U.S. Department of the Interior **BUREAU OF LAND MANAGEMENT** Sundry Print Repor

Well Name: LOST TANK 30-19 Well Location: T22S / R32E / SEC 19 / County or Parish/State:

Sundry ID: 2758996

Type of Submission: Notice of Intent Type of Action: APD Change

Wellhead diagram during offline cementing operations

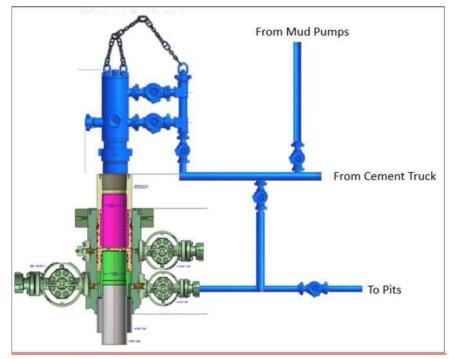
Offline Cementing Variance Request

Oxy requests a variance to cement the 9.625" and/or 7.625" intermediate casing strings offline in accordance to the approved variance, EC Tran 461365.

- 8. Install offline cement tool
- 9. Rig up cement equipment

- 10. Circulate bottoms up with cement truck
 - a. If gas is present on bottoms up, well will be shut in and returns rerouted through gas buster to handle entrained gas
 - b. Max anticipated time before circulating with cement truck is 6 hrs
- 11. Perform cement job taking returns from the annulus wellhead valve
- 12. Confirm well is static and floats are holding after cement job
- 13. Remove cement equipment, offline cement tools and install night cap with pressure gauge for monitoring.

Falcon SL1 Contingnecy Tieback Details

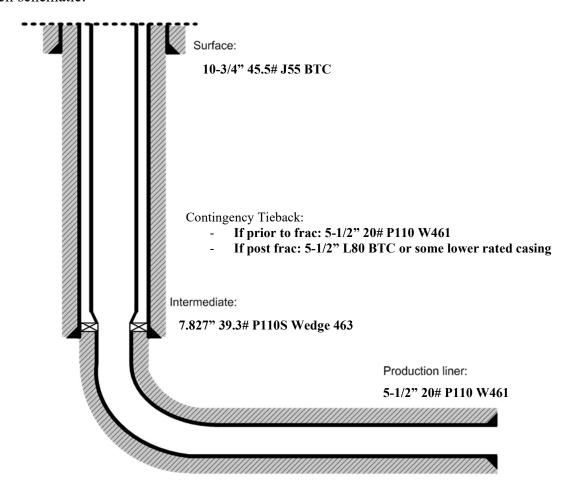
- o Pump hydraulic fracture job.
 - Flowback and produce well.
- If contingency tieback required post-frac:
 - o Move in workover rig and run a 5-1/2" L80 BTC or lesser rated tie-back string and seal assembly. Tie into liner hanger Polished Bore Receptacle (PBR) with seal assembly.
